DRAINAGE LETTER REPORT
for
LOT 1A, FALCON MARKETPLACE

7520 Falcon Market Place
Falcon, Colorado

September 15, 2023

PCD File No: PPR-236

PROPOSED
DRAINAGE
PLAN

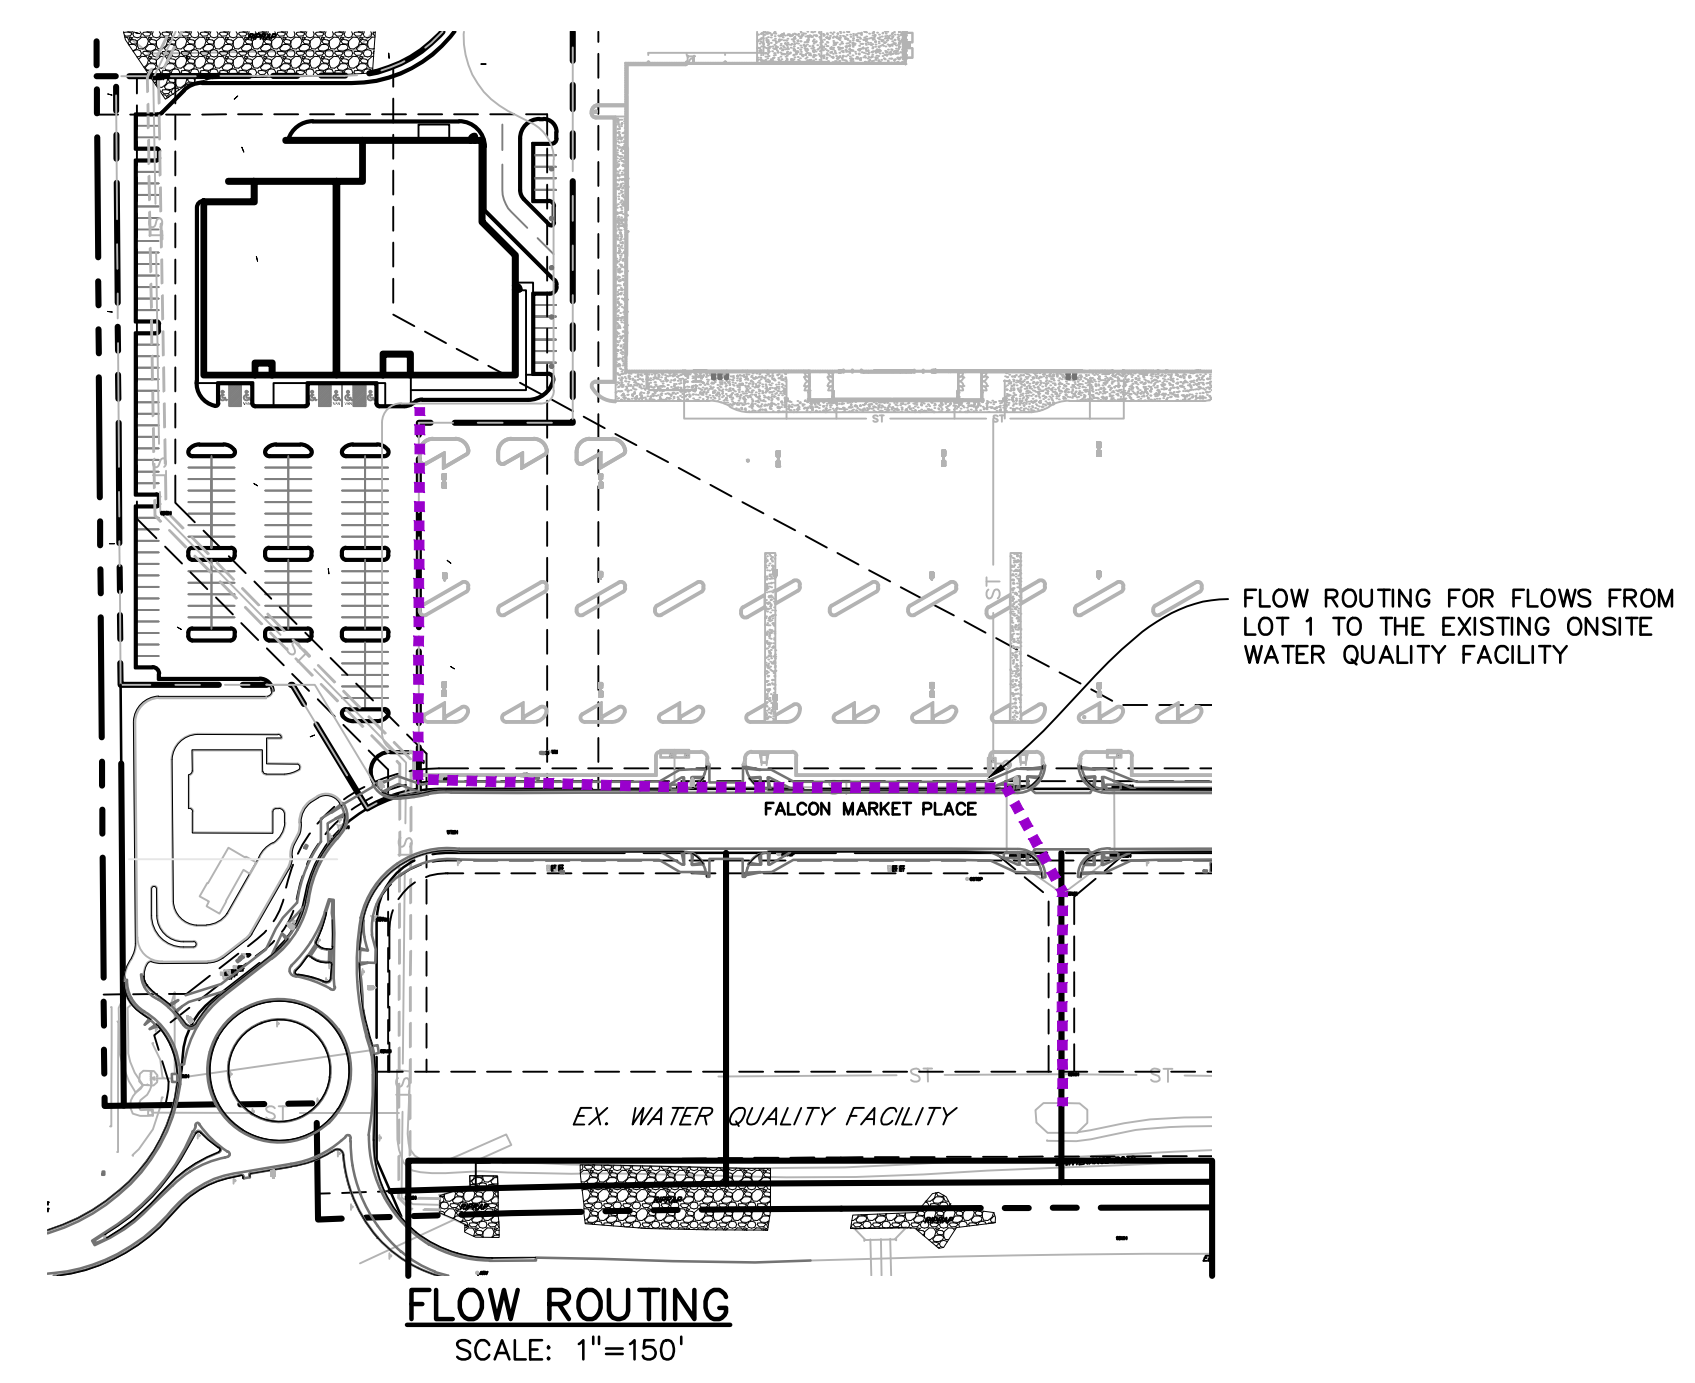
as indicated in the narrative address the fact that site is within the spillways path. Be sure to address whether the adjacent westerly lot will be impacted.

Please revise label. The report states this will be 18" RCP.

Please adjust flow arrows for Basin C. The narrative states flows go towards Design Point 3A.

identify the ultimate flow at this location and compare to what was indicated in the Falcon marketplace drainage report
